HATCH - UNIT 1

HATCH - UNIT 2

TECHNICAL SPECIFICATIONS REVISIONS ROR RWM AND RSCS OPERATION, FUEL STORAGE REQUIREMENTS, FUEL ASSEMBLY DESIGN, MAPLHGR LIMITS, EDITORIAL CHANGES PROPOSED CHANGES TO TECHNICAL SPECIFICATIONS REFERENCED DOCUMENTS

UEL TYPES P8DRB265H AND BP8DRB265H 80 AND 100 MIL CHANNEL MAXIMUM AVERAGE PLANAR LINEAR HEAT GENERATION RATE (MAPLHGR) VERSUS AVERAGE PLANAR EXPOSURE FIGURE 3.2.1-7

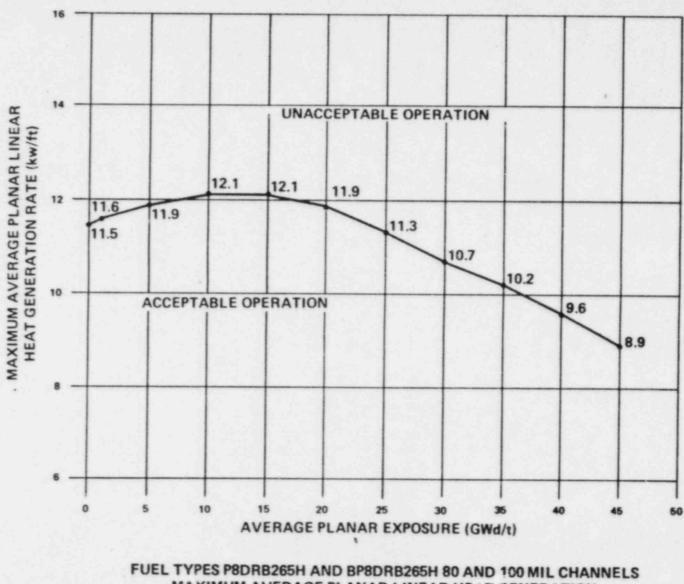
- Add results for the P8DRB283 80 mil bundle to supplement the 100 mil results.
- 2) Revise the P8DRB284H MAPLHGR's to bound both 80 and 100 mil results.
- Add clarifying notes to specify that the P8DRB265H and P8DRB299 results bound 80 and 100 mil results.
